attachment 5 to item 3

Addendum

CP - Planning Proposal to Amend Hawkesbury Local Environmental Plan 2012 to Permit Residential Subdivision of Lots 1 and 3 DP 596558, and Lots 209 and 210 DP 260361, 16 William Cox Drive, Richmond.

TERRACE TYPOLOGY

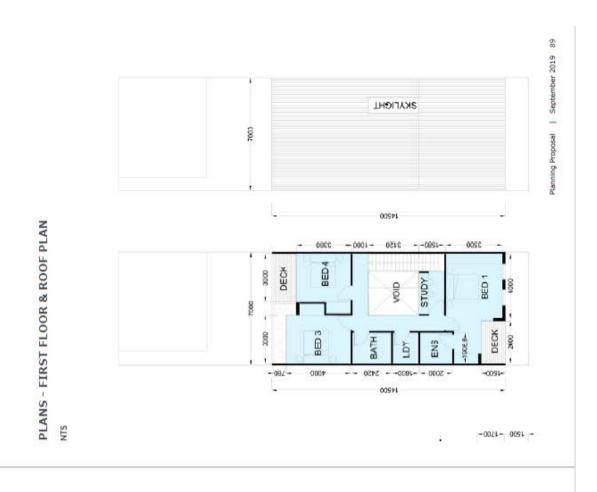
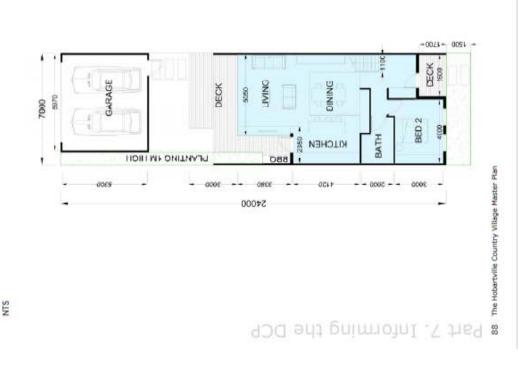
Whilst the amended Planning Proposal does not specify a minimum lot size, the terrace typology provided shows that an average lot size of 178.5m2 will be required for each of the 81 terrace dwellings.

However, as discussed in the original Report, it is considered that the density resulting from the development of up to 12 attached terrace houses in one location is not considered to be in keeping with the existing character of the locality and will not be consistent with the objectives of the R2 Low Density Residential zone, irrespective of the minimum lot size proposed.
